Fargo VAMC – Refurbish Elevators and Replace Controls

Fargo, North Dakota
Project #19-2481

MARCH 26, 2024

ADDENDUM NO. 2

Drawing Number
AD5.20

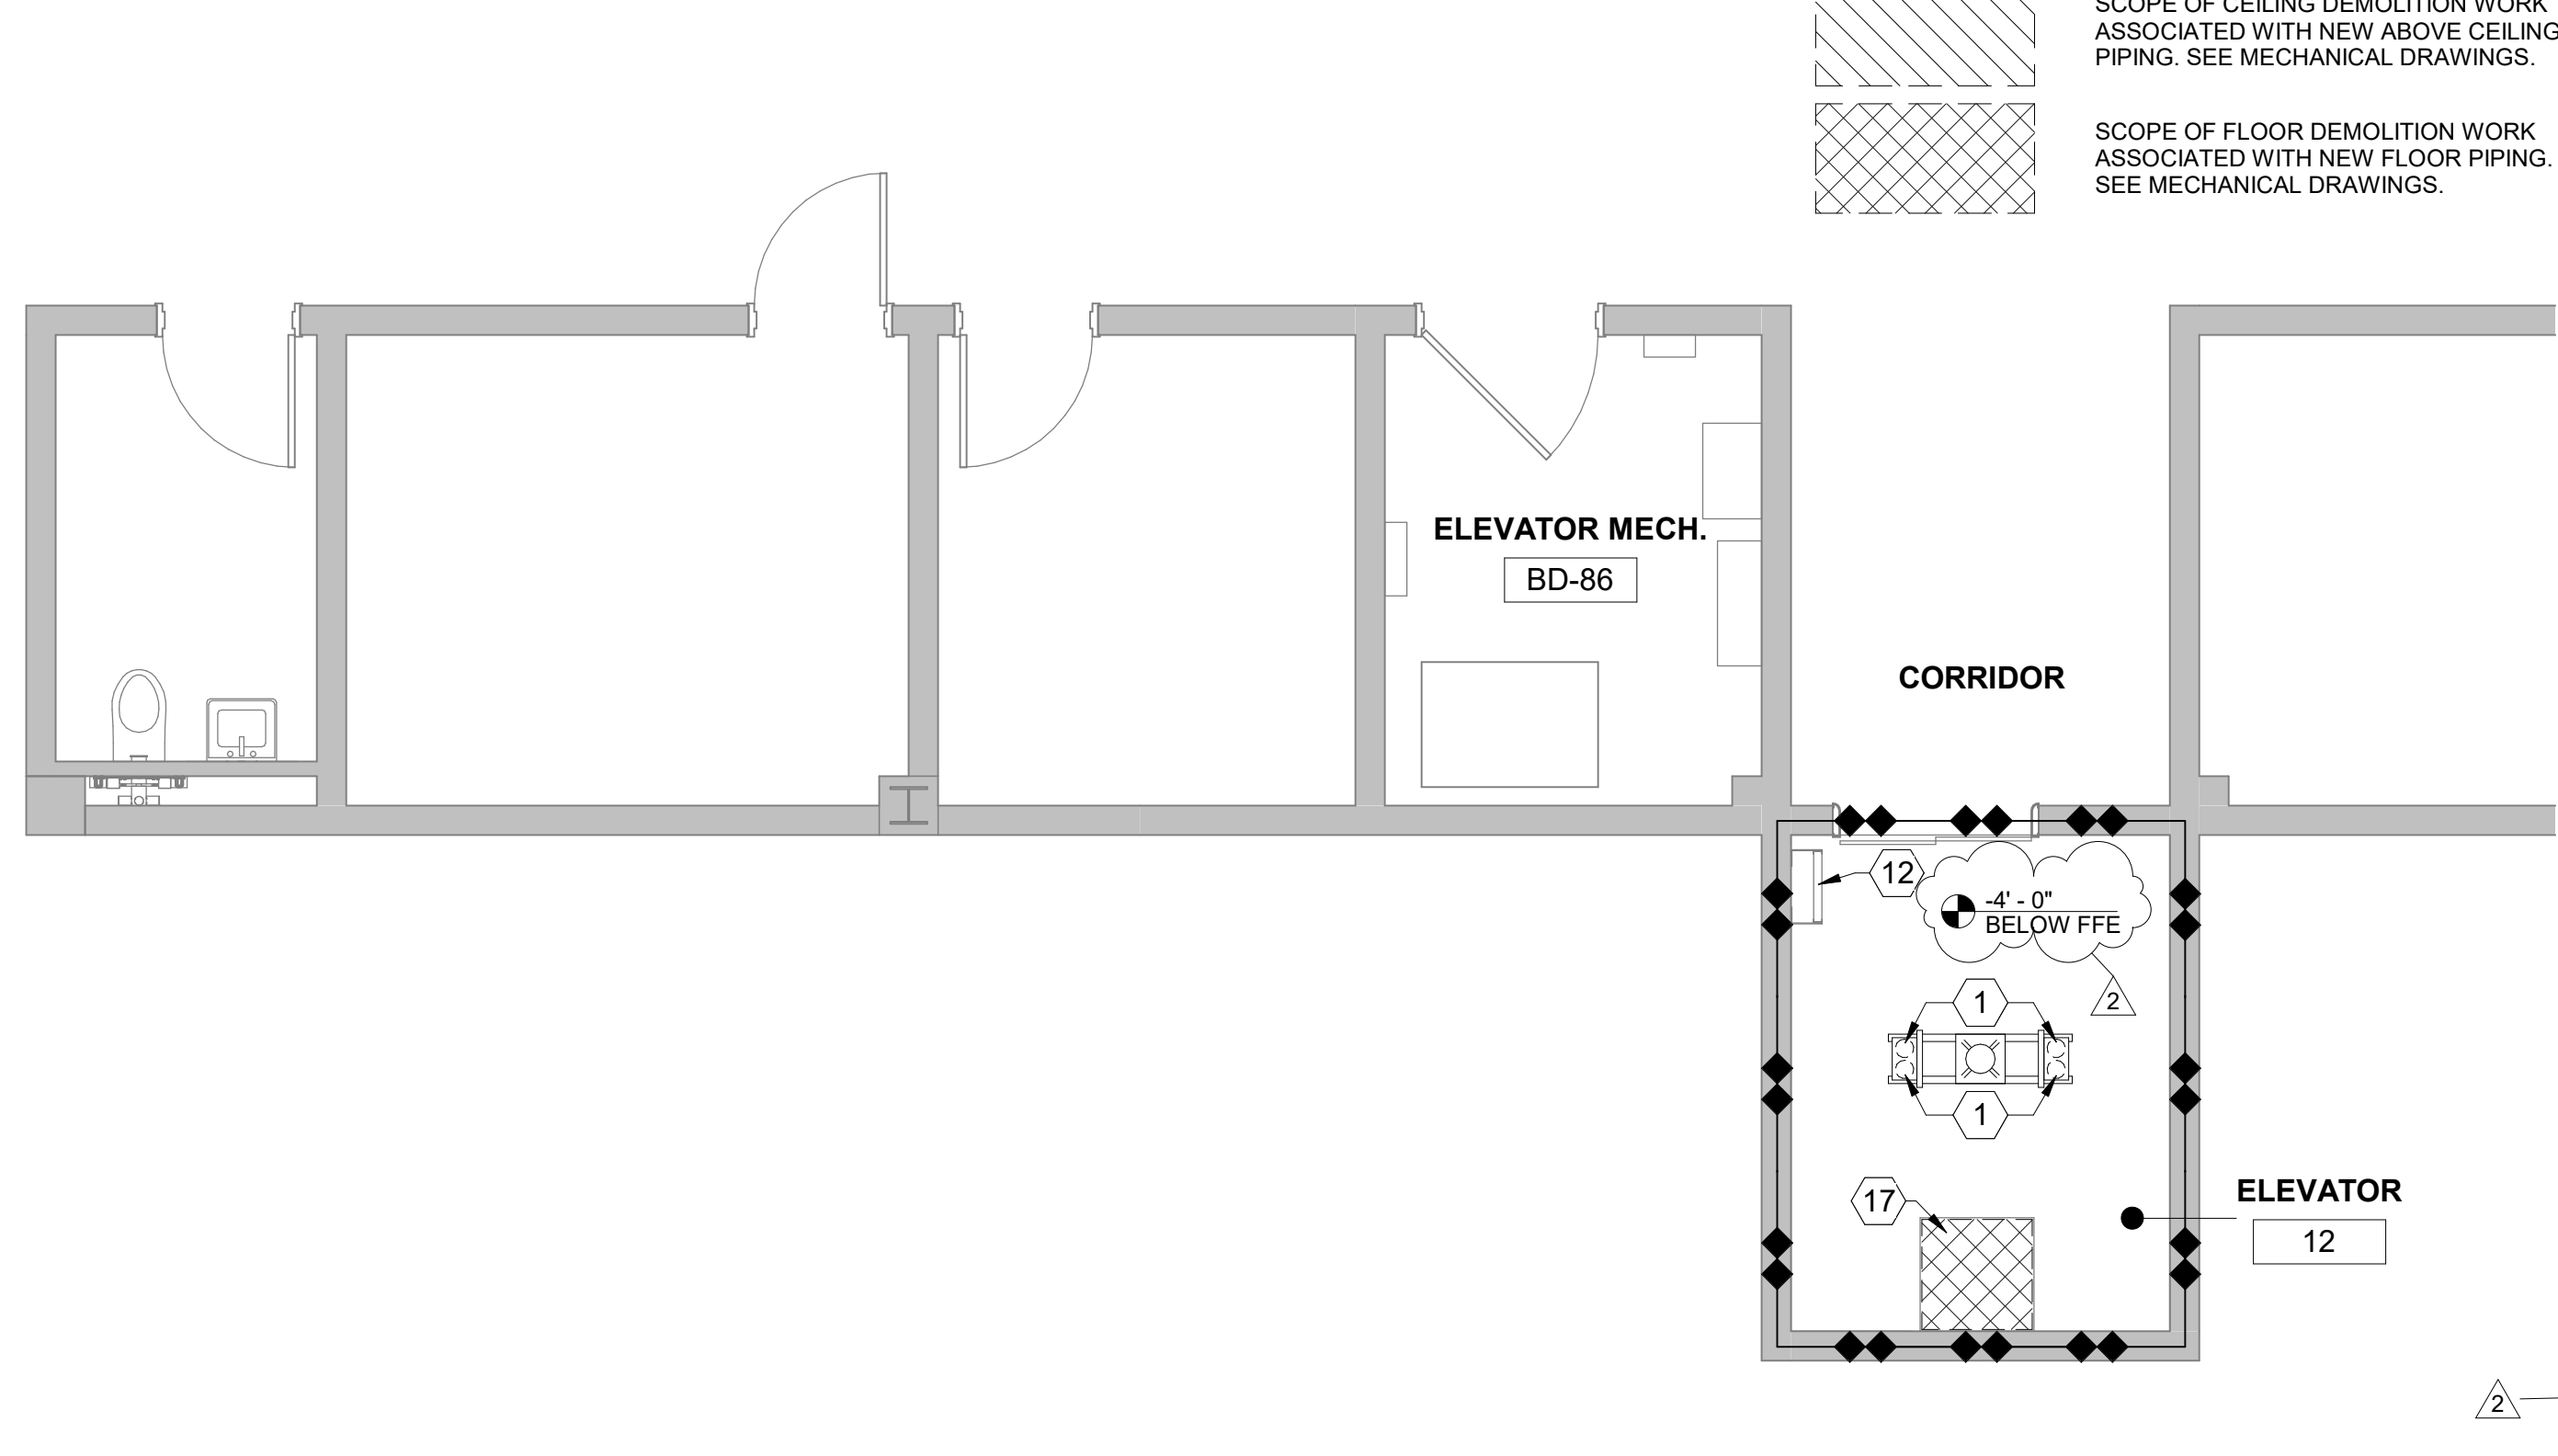
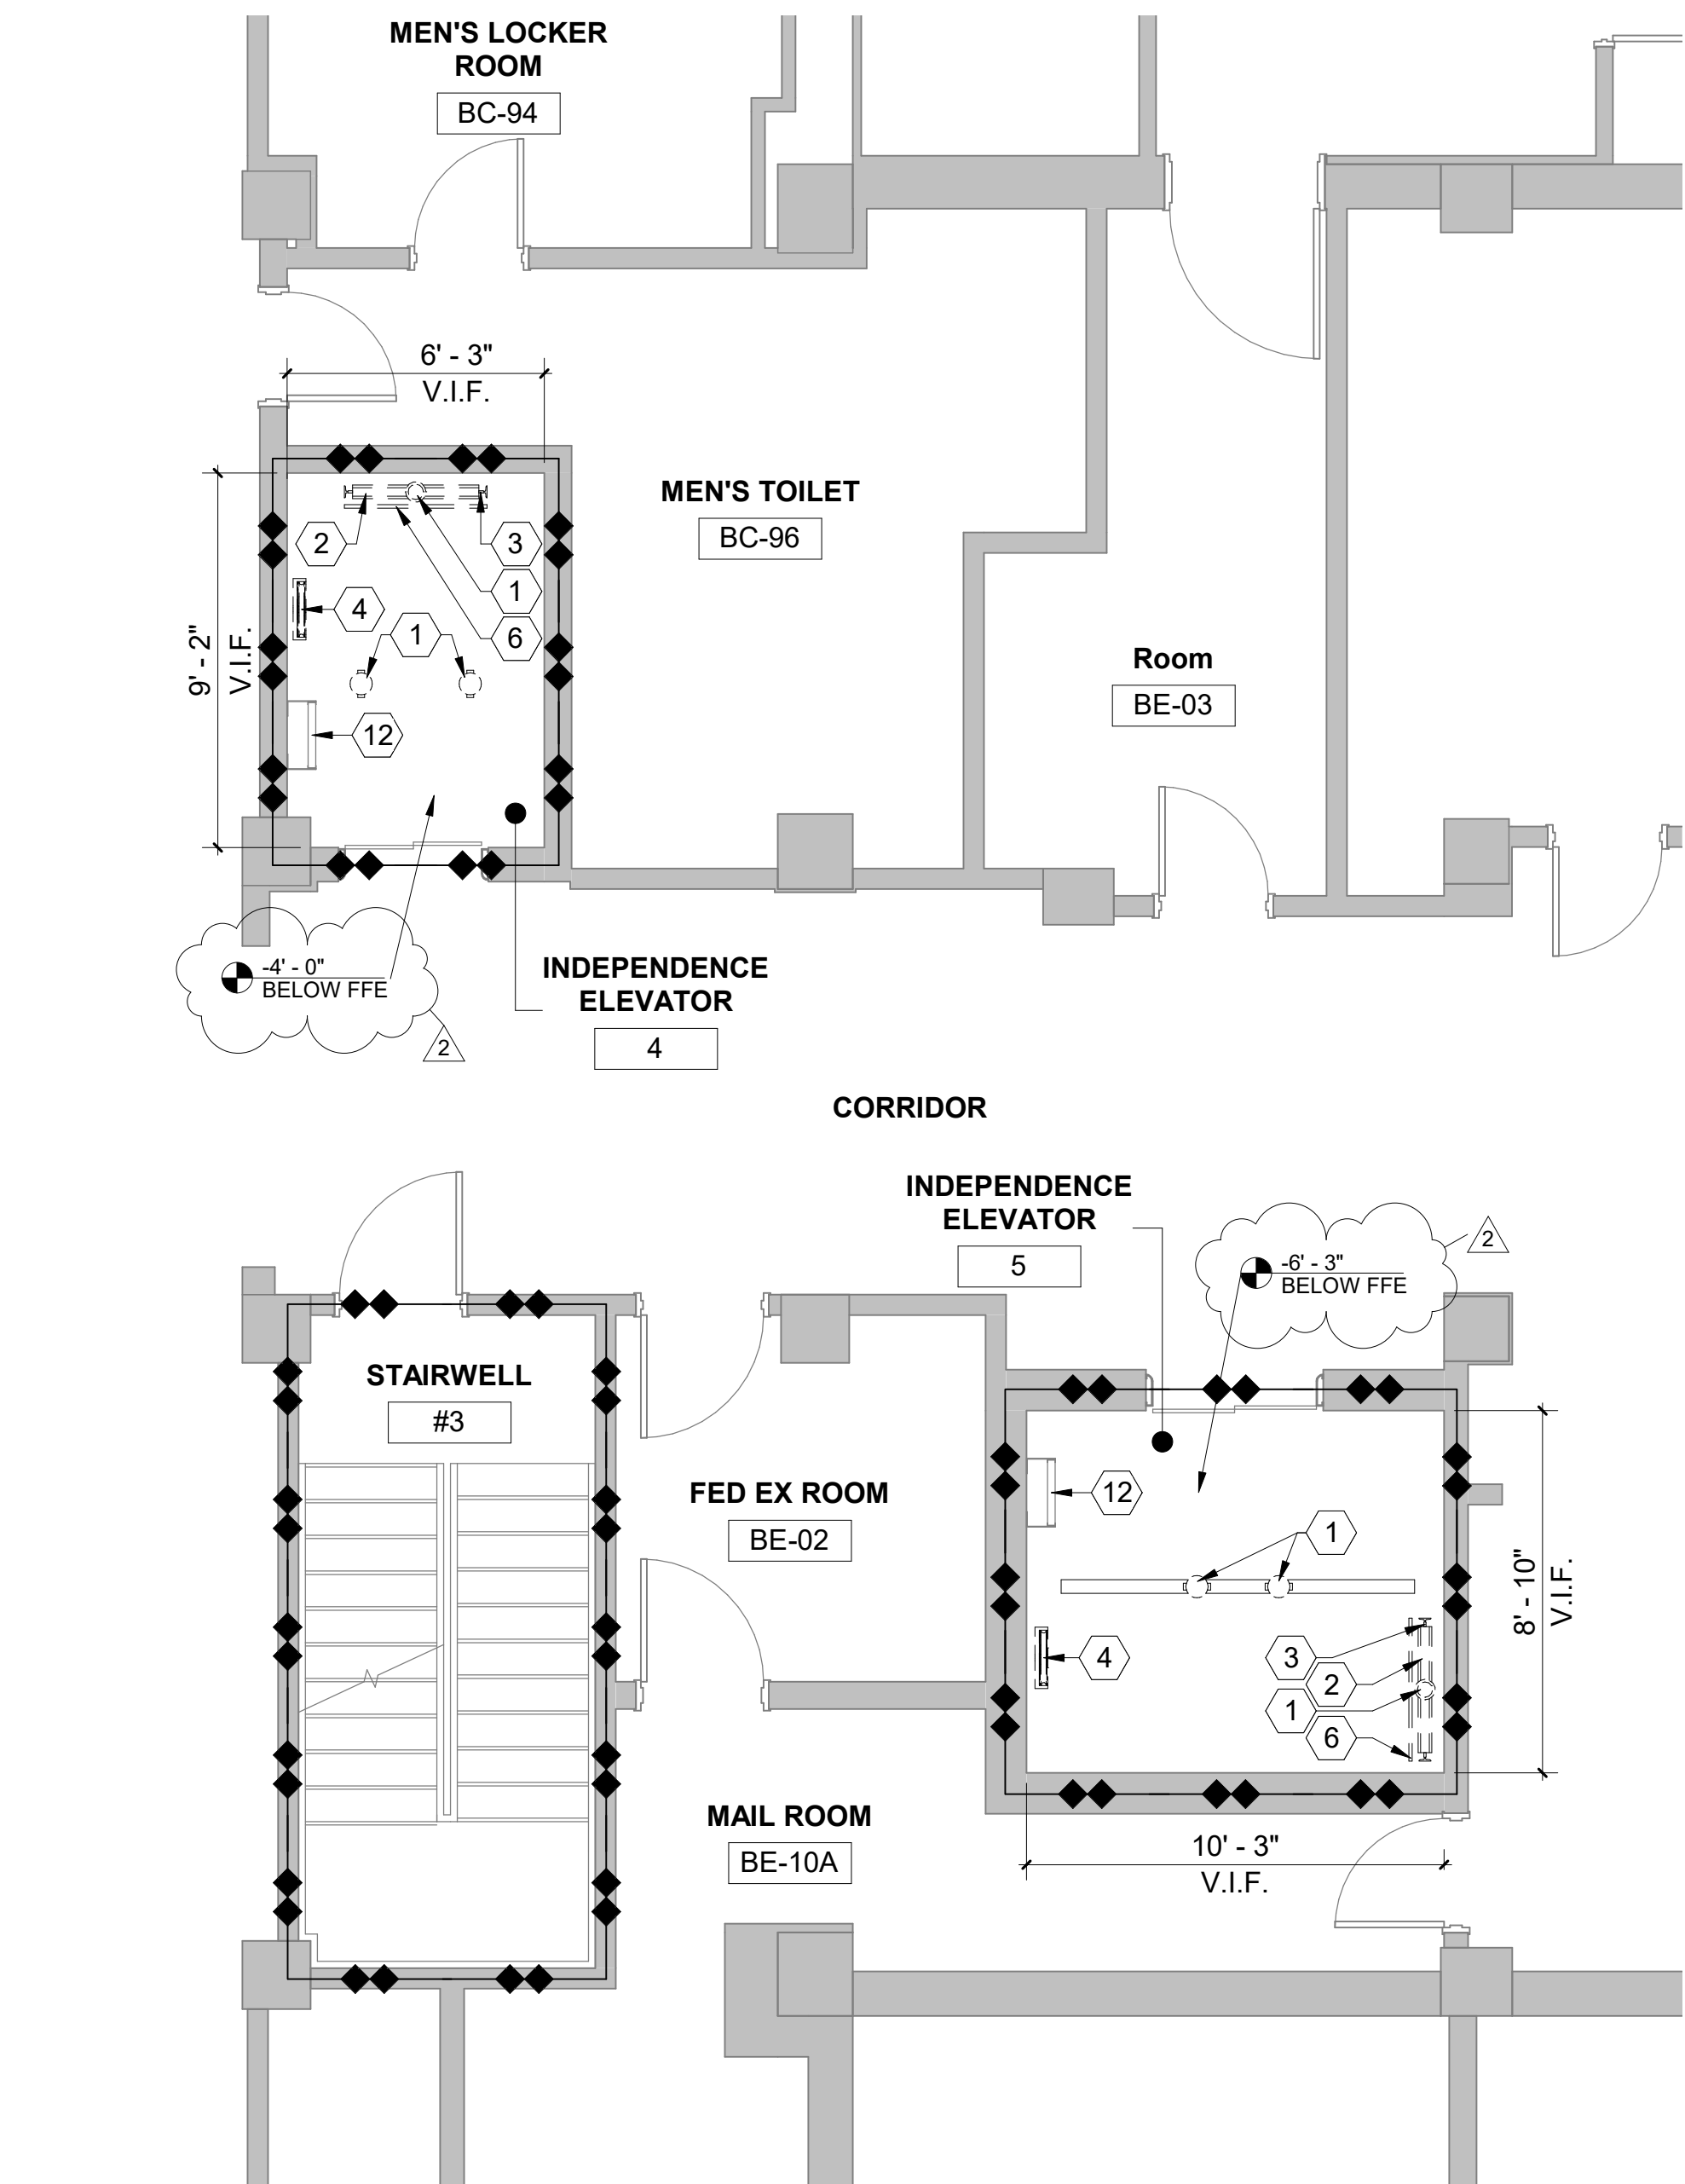
Drawing Sheet AD5.20 ENLARGED PLANS - DEMOLITION – See revised drawing sheet for the adjustment of keynotes # 3, 9, 13 15, 16. Also included is the depth of each elevator pit relative to the floor elevation at the lowest elevator lobby for each hoistway.

- EXISTING METAL PIT LADDER TO REMAIN.
- EXISTING HYDRAULIC PISTONS/JACKS TO REMAIN AND BE REPACKED.
- NOT USED.
- EXISTING LOWER SECTION OF GUIDE RAILS TO BE REMOVED AND REPLACED (APPROX 20LF AT EACH RAIL). INSTALL TO COORDINATE WITH OTHER NEW EQUIPMENT. PROVIDE NEW MOUNTING BRACKETS. APPLIES TO ELEVATOR 7 AND 8 ONLY DUE TO WATER DAMAGE.

- EXISTING LOWER SECTION OF COUNTERWEIGHT RAILS (APPROX 20 LF AT EACH RAIL) AND PIT GUARD TO BE REMOVED AND REPLACED. INSTALL TO COORDINATE WITH OTHER NEW EQUIPMENT. PROVIDE NEW MOUNTING BRACKETS. APPLIES TO ELEVATOR 7 AND 8 ONLY DUE TO WATER DAMAGE.
